GOVERNMENT OF THE DISTRICT OF COLUMBIA
Department of Energy and Environment

MEMORANDUM

SUBJECT: [Z.C. CASE NO.](#) 17-05 2100 2nd Street SW, LLC (River Point) - CG Overlay
Design Review on Lot 10 in Square 613

Figure 2: 10-year event under current conditions

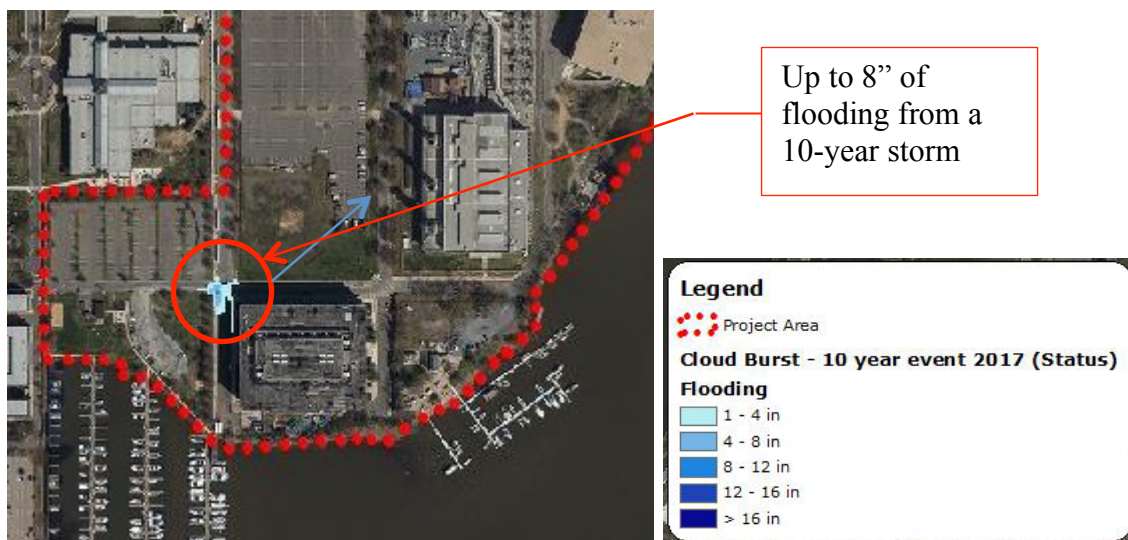
- DOEE has engaged an engineering and resilience planning consulting firm to perform initial investigations including topographical and hydronic modeling to determine the impacts of flooding on the Buzzard Point neighborhood and identify potential solutions.
 - Initial findings have shown the most significant flooding risk from today's 10-year rain event (10% chance of occurring in a given year) at the intersection of 2nd and V Streets, which would block the planned bus route and make access to the parking garage and commercial spaces more difficult (figure 2).

Figure 3: 100-year event under current conditions

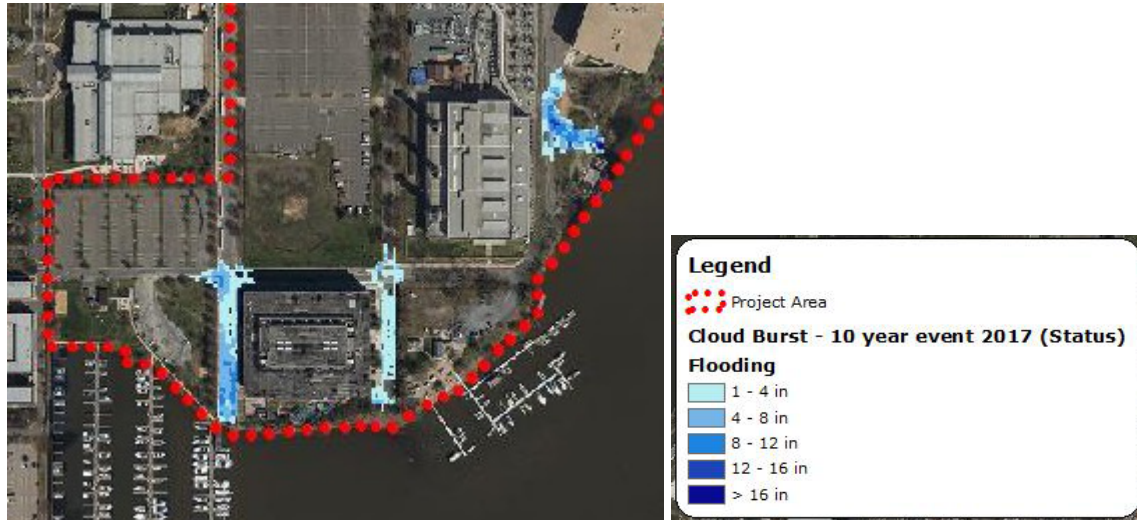
- More severe storm events such as today’s 100-year rain event, or a storm with a 1% annual chance of occurring in today’s climate, would cause significant flooding and standing water along 1st and 2nd streets (figure 3).

Figure 7: 1000-year storm surge

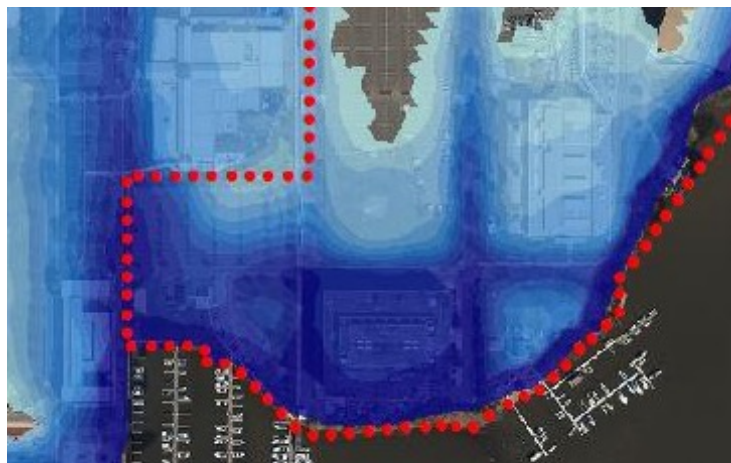
- Storm surge and riverine flooding:**
 - The scenarios above do not include impacts from storm surge and riverine flooding from coastal storms such as Hurricane Sandy or Hurricane Isabel. The following images show the impacts for today's 100-year and 500-year storms and the worst case proposal, a 1000-year storm event (0.1% chance of occurring), which is used as the design case in the Netherlands.

Although the modeling on the left does not account for climate change and rising sea levels, it is clear to see that the predicted impacts from storms would be severe. Design considerations on a project-by-project basis, as well as planning for neighborhood resiliency through multiple layered strategies, will be necessary.

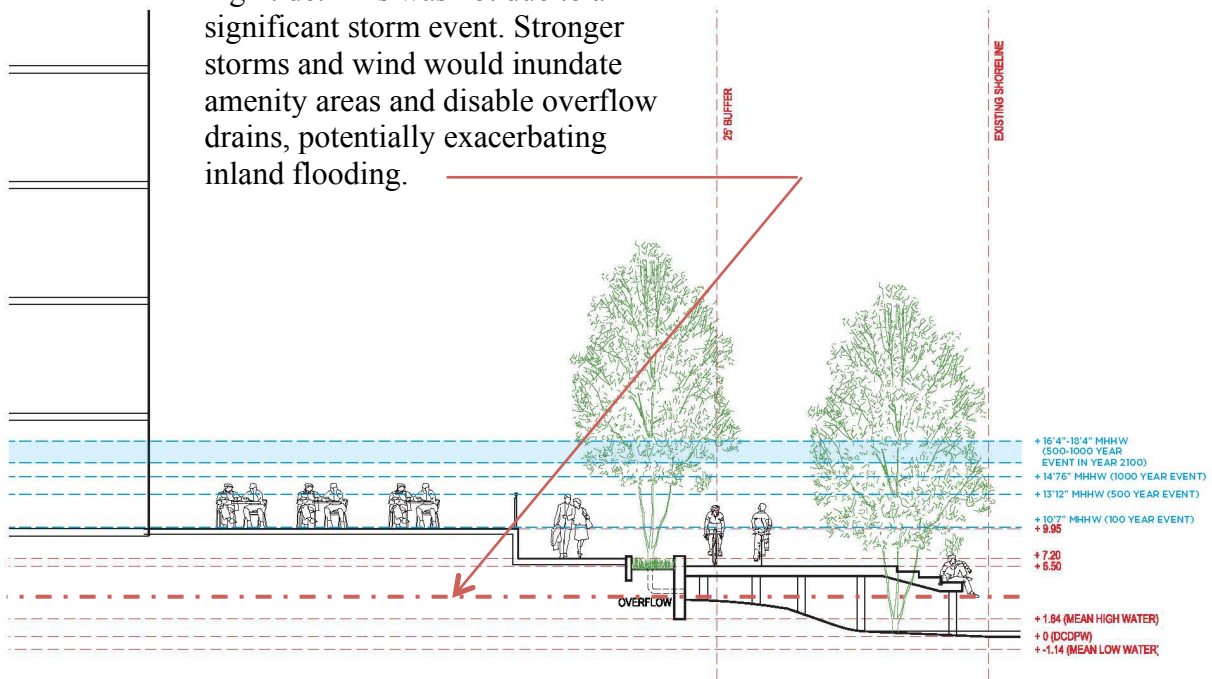
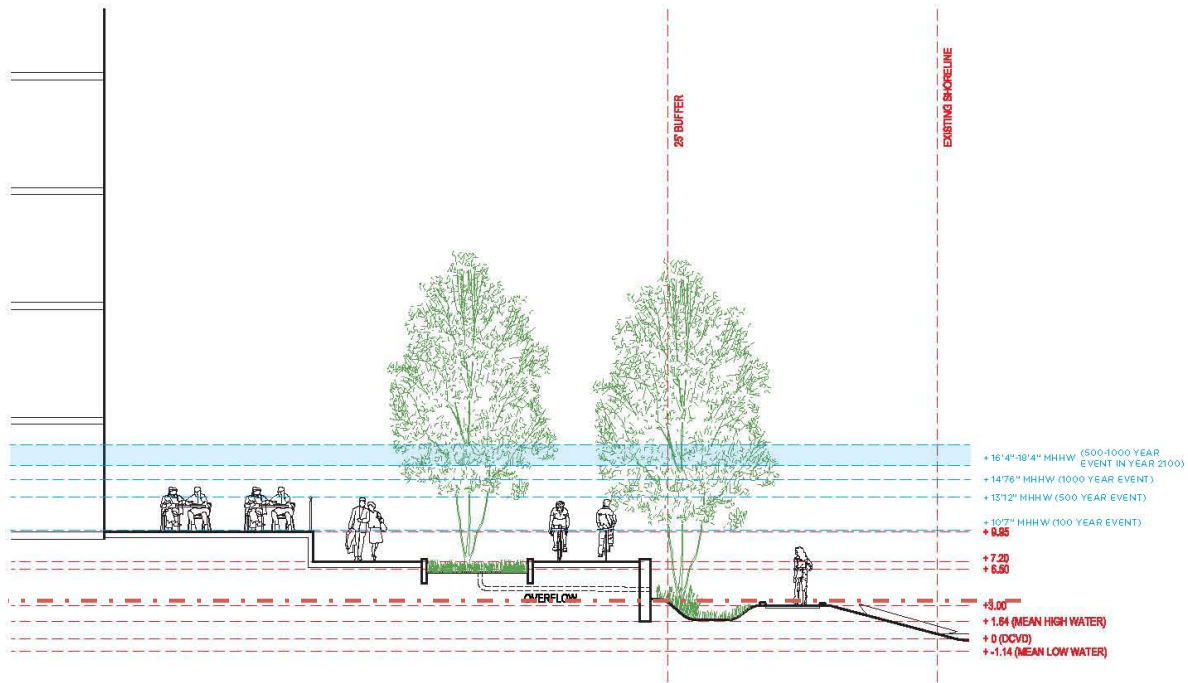
- If we translate the data shown in the plans above to the section renderings included in the submission, the impacts of sea level rise and storm surge on the current design become evident.

As an example of standard conditions, nuisance flooding was observed on May 25, 2017 to be 1.5' higher than the mean high-high tide. This was not due to a significant storm event. Stronger storms and wind would inundate amenity areas and disable overflow drains, potentially exacerbating inland flooding.

- The MHHW is the mean of the higher of the two diurnal tides – which is important from a flooding perspective. The plans include a reference to mean high water (MHW) but not MHHW. Additional survey and detail is necessary to locate this datum along with setbacks required under the regulations and to ensure that proposed amenity spaces are designed with topography above daily inundation levels.

- The required 25-foot natural buffer should be measured from the top of bank and include planted surfaces and steep slopes that help to soften rising flood water and shed debris. Per the Comprehensive Plan Policy E 1.2.1, open spaces should restore vegetation, reduce erosion, and enhance wildlife habitat.

- **DOEE recommends that the project take measures that would account for and provide greater resiliency due to the increased flood risks and storm surge resulting from climate change. This would include raising occupied space above the 500-year floodplain, dry flood proofing, locating main exits**
